# Access Compliance Report

## Public Rights-of-Way (Curb Ramps)

Intersection ID: 50614	Main Street: PADDLE_OAK_RD	Cross Street: BALSAM_BAY_RD	Location: NW
ADA ID: DB54909CD36A	Ramp Type: Perp	Initial Pass/Fail: Fail	Overall Compliance: No
Severity Score: 13.75			
Codes/Mitigation Info/Possible Solution		Field Measurements/Component Compliance

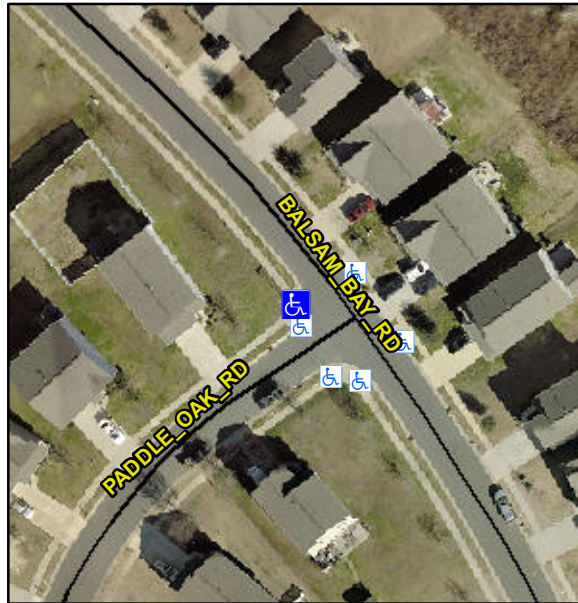
**R304.2.2, R304.5.3**

Compliance	Description	Data	Compliance	Description	Data
N/A	Ramp Length (in)	48.0	No	Ramp Slope (%)	9.2
Yes	Ramp Width (in)	48.0	No	Ramp XSlope (%)	4.6
N/A	Flare Type LT	N/A	N/A	Flare Type RT	N/A
N/A	Flare Slope LT (%)	N/A	N/A	Flare Slope RT (%)	N/A
N/A	Flare Traversable LT?	N/A	N/A	Flare Traversable RT?	N/A
N/A	Landing Length (in)	N/A	N/A	DWS Provided?	N/A
N/A	Landing Width (in)	N/A	N/A	DWS Contrast?	N/A
N/A	Landing Slope (%)	N/A	N/A	DWS Length (in)	N/A
N/A	Landing X Slope (%)	N/A	N/A	DWS Full Width?	N/A
N/A	Landing Curb? (Y/N)	N/A	N/A	DWS Offset (in)	N/A
N/A	Shared Landing?	N/A			
N/A	Gutter Ponding?	N/A	N/A	Gutter Slope (%)	N/A
N/A	Gutter Lip Ht (in)	N/A	N/A	Gutter X Slope (%)	N/A
N/A	Painted X Walk1?	No	N/A	Painted X Walk2?	N/A
	X Walk 1 Direction	To E		X Walk 2 Direction	N/A
N/A	X Walk 1 Width (in)	N/A	N/A	X Walk 2 Width (in)	N/A
	X Walk 1 Slope (%)	2.4		X Walk 2 Slope (%)	N/A
	X Walk 1 X Slope (%)	4.1		X Walk 2 X Slope (%)	N/A

**Remove & Replace Entire Ramp.**
